Technical Service Bulletin

34 - 6th gear jumps out - 0B1/0B2 gearbox

34 13 14 2026719/3 January 30, 2013. Supersedes Technical Service Bulletin Group 34 number 11-04 dated June 21, 2011 for reasons listed below.

Figure 1. Shift fork and gear shift unit

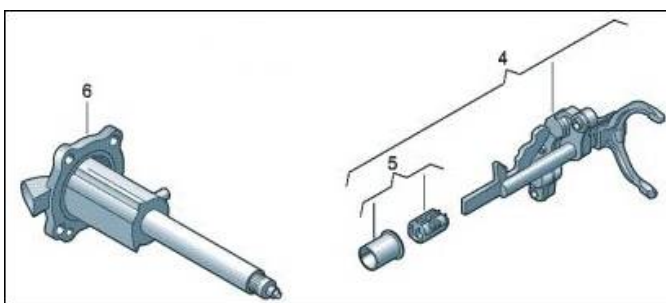
4. Replace the 5th -6th gear shift fork and ball sleeve (*Item 4 and 5, Figure 1*) and the gear shift unit (*Item 6 Figure 1*) per instructions in *ELSA: Transmission*>> *Manual Transmission Internal Components*>> *34 Controls, Housing*>> *Disassembly and Assembly*>> *Transmission, Assembly Sequence AND 35 Gears, Shafts*>> *Disassembly and Assembly*>> *Shift Fork Group, input shaft*.

Tip: When replacing the shift fork and ball sleeve, **no** further disassembly of input shaft is required.
